NCIA/ACQ/2020/7049
10 September 2020

Subject : **IFB-CO-15049-BITI: INVITATION FOR BID
Technical Refresh of Balkans IT Infrastructure, Amendment 7 and Clarification
Requests Release # 7**

ANNEX A: Clarification Requests Response Release No 7

Figure 14: DC and ROBO site IaaS architecture

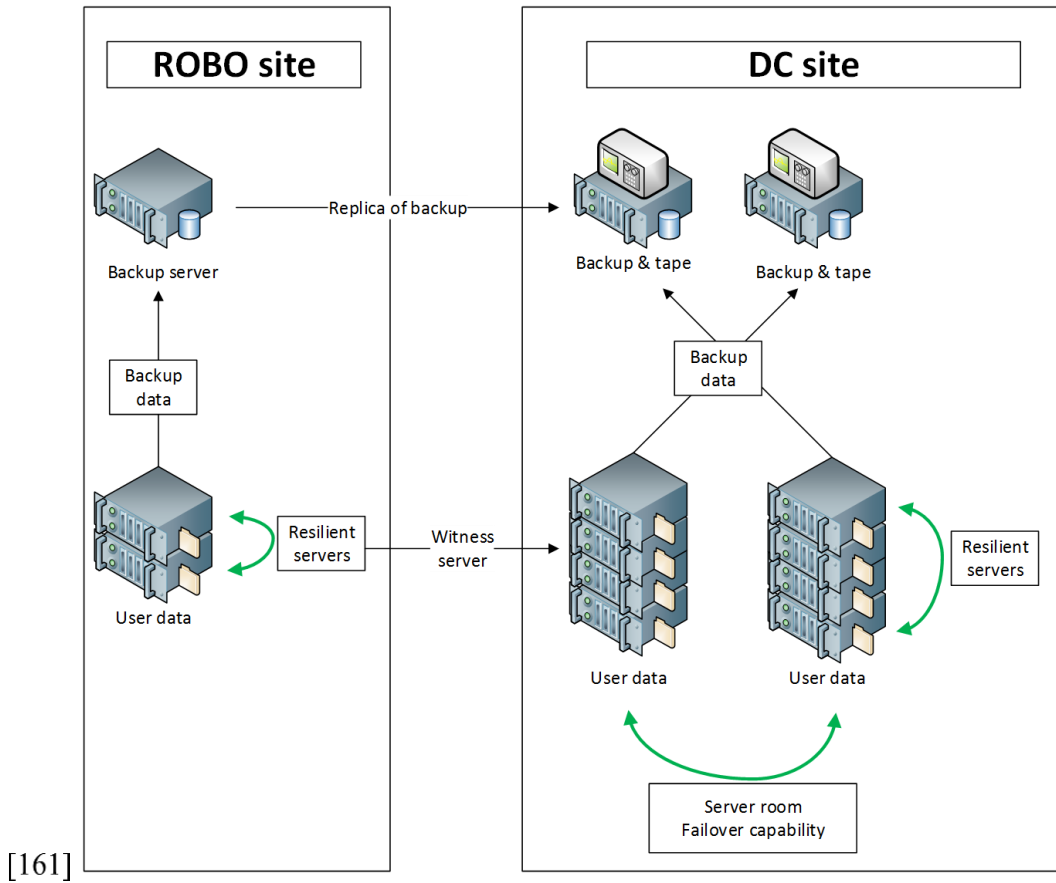
36	09_IFB-CO-15049-BITI_Book II - Part IV SOW Annex A System Requirements Specifications	<p>3.5.2 Installation (172) The IaaS services shall be installed to provide a Data center (DC) to Remote Office Branch Office (ROBO) architecture (see diagram below) at identified locations and network classifications. ROBO locations will have a minimal IT footprint with a local backup capability, services will also be accessed from the DC and critical data and backups shall be replicated to the DC from the ROBO location.</p> <p>According to Figure 14: DC and ROBO site IaaS architecture for NLO Skopje ROBO location doesn't contain tape library in IT footprint but we need to offer it 03_IFB-CO-15049-BITI_Book I - Annex A Bidding Sheets (MS Excel) 6,4 NHQ Skopje (NU) fields 6.4.7 and 6.4.8.</p> <p>Could you confirm that all Quantities in 03_IFB-CO-15049-BITI_Book I - Annex A Bidding Sheets (MS Excel) column (H) are correct and we can calculate with them?</p> <p>Annex A Hardware and Software Requirements Can you confirm that all minimal hardware and software requirements are correct and sufficient, and can we calculate with them in 03_IFB-CO-15049-BITI_Book I - Annex A Bidding Sheets (MS Excel)? For example: [183] The vSAN Datacenter Cluster nodes shall use an all-flash configuration to maintain storage performance on virtual servers. - listed configuration for VIRTUAL HOST servers A.1.8 – A.1.10 is not all flash as described in "09_IFB-CO-15049-BITI_Book II - Part IV SOW Annex A System Requirements Specifications" (182) The IaaS VMware vSAN Datacenter shall be installed as a five (5) host cluster to provide the following resources for the virtual servers:(1) 270Tb of raw storage (2) 205 vCPU (3) 610 vRAM We notice that A.1.8 Virtual Host Server and Storage (Large) cannot</p>	<p>Yes, the quantities of equipment stated in the Bidding Sheets and the specifications are authoritative and shall be used when evaluating bids.</p>
